Access Compliance Report

Public Rights-of-Way

Intersection ID: 50272	Main Street: SOUTH_BV	Cross Street: WHITTON_ST	Location: NE
ADA ID: 77C8F2C490DD	Ramp Type: Perp	Initial Pass/Fail: Fail	Overall Compliance: No
Severity Score: 22.5			
Codes/Mitigation Info/Possible Solution		Field Measurements/Component Compliance

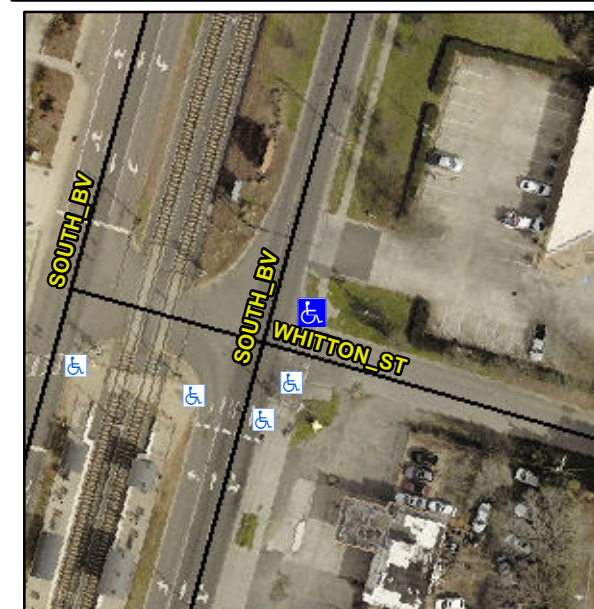
Not Found, R304.5.1, R304.2.2

Compliance	Description	Data	Compliance	Description	Data
N/A	Ramp Length (in)	71.5	No	Ramp Slope (%)	8.5
No	Ramp Width (in)	47.0	Yes	Ramp XSlope (%)	2.6
N/A	Flare Type LT	N/A	N/A	Flare Type RT	N/A
N/A	Flare Slope LT (%)	N/A	N/A	Flare Slope RT (%)	N/A
N/A	Flare Traversable LT?	N/A	N/A	Flare Traversable RT?	N/A
N/A	Landing Length (in)	N/A	N/A	DWS Provided?	N/A
N/A	Landing Width (in)	N/A	N/A	DWS Contrast?	N/A
N/A	Landing Slope (%)	N/A	N/A	DWS Length (in)	N/A
N/A	Landing X Slope (%)	N/A	N/A	DWS Full Width?	N/A
N/A	Landing Curb? (Y/N)	N/A	N/A	DWS Offset (in)	N/A
N/A	Shared Landing?	N/A			
N/A	Gutter Ponding?	N/A	N/A	Gutter Slope (%)	N/A
N/A	Gutter Lip Ht (in)	N/A	N/A	Gutter X Slope (%)	N/A
N/A	Painted X Walk1?	Yes	N/A	Painted X Walk2?	N/A
	X Walk 1 Direction	To SW		X Walk 2 Direction	N/A
N/A	X Walk 1 Width (in)	111.0	N/A	X Walk 2 Width (in)	N/A
	X Walk 1 Slope (%)	3.0		X Walk 2 Slope (%)	N/A
	X Walk 1 X Slope (%)	3.3		X Walk 2 X Slope (%)	N/A

Remove & Replace Entire Ramp.
